DATE: April 8, 2014

TITLE: 700 East Middlefield Road (RREEF) Project

The purpose of this Study Session is to present the City Council with an updated plan for the RREEF office project at 700 East Middlefield Road and to receive Council feedback and direction.

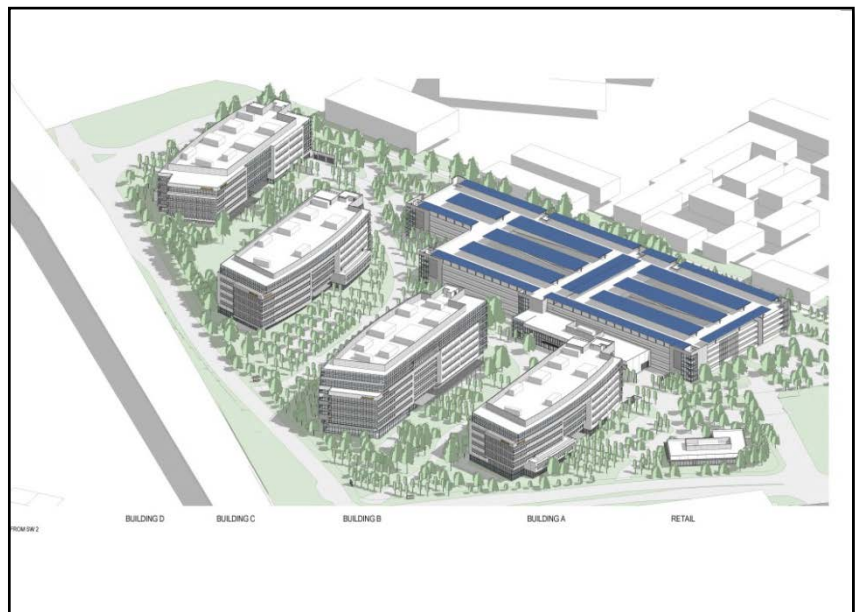
The applicant provided a revised site plan to staff in March 2014. The applicant proposed a circulation hierarchy and clear distinction paths of travels for vehicles, bicyclists, and pedestrians. The circulation hierarchy is a step in the right direction, but the proposed circulation routes are circuitous. Staff recommends more direct connections through the campus with routes that lead to a clear center of the campus. Although the applicant addressed DRC comments by creating a circulation hierarchy and emphasizing a campus center, staff finds the site plan does not create a cohesive campus because Buildings C and D still feel disconnected from the campus center.

The applicant refined the primary entrance between Buildings B and C by creating a bicycle/pedestrian pathway adjacent to the driveway and a pedestrian-only path connecting Buildings B and C. However, Buildings B and C are still separated by two parking lots. Staff finds the parking lots contribute strongly to Buildings B and C not addressing each other. Staff recommends removing the parking from between the buildings so they address each other better. In addition, staff recommended moving the parking to the corners of the building away from the street. These are recommendations previously provided by the DRC.

Staff recommends the north/south driveway through the site (meandering from Maude Avenue to Bernardo Avenue) be realigned to provide a more direct connection through

the site, which may require changes to building location. This recommendation is similar to the recommendation provided by the DRC.
